Catherine H. Reheis-Boyd
President

August 27, 2020

Re: WSPA Supplemental Written Comments for August 27, 2020 Public Hearing to Consider Proposed Control Measure for Ocean-Going Vessels At Berth

Figure 1. 2016 Statewide At-Berth PM_{2.5} emissions by Vessel and Engine Type

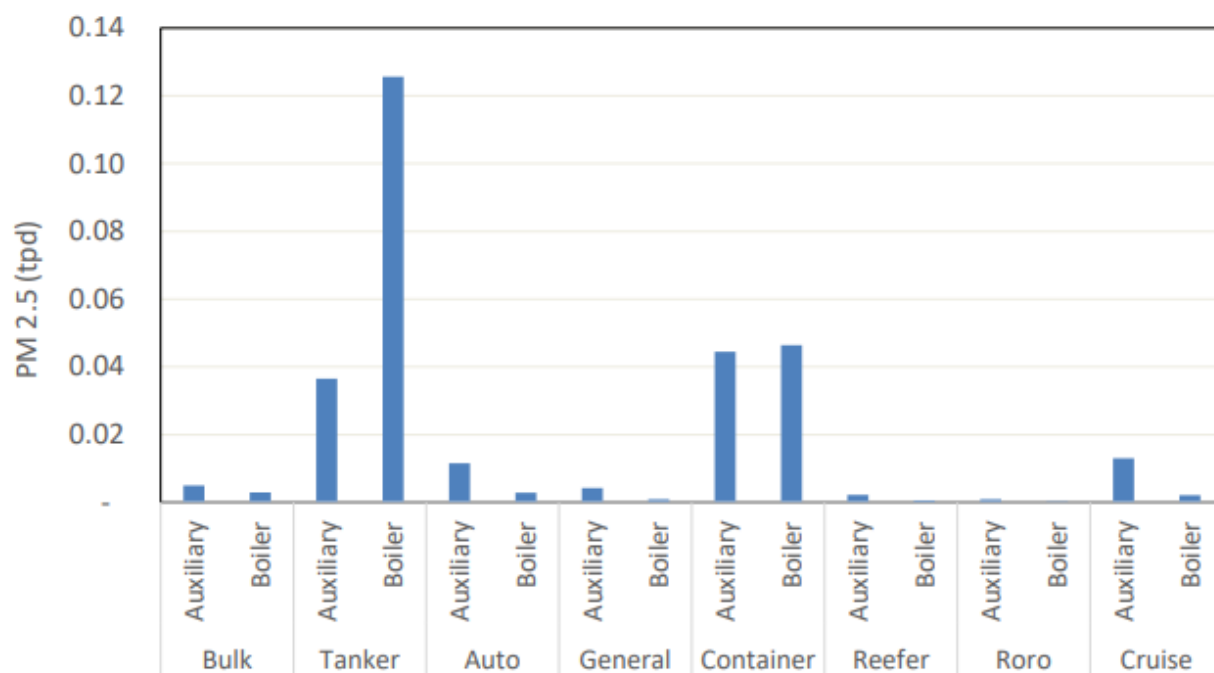
As shown above, the tested boiler exhibited significantly lower emissions than those estimated from AP-42. In ARB's 2016 inventory used for regulatory development⁶, calculated PM_{2.5} emissions from tanker boilers is a significant part of their inventory as shown in Figure 1.

The above figure shows approximately 0.125 tpd from tanker boilers and another 0.035 tpd from tanker auxiliary engines while at berth. Total PM_{2.5} from all ship types is roughly 0.3 tpd. If the new emission factors were applied for boilers the boiler emissions would be 0.12 tpd lower. That would lower the tanker impact from 50 percent of PM_{2.5} emissions from all ships to 22 percent making it less important than container ships.
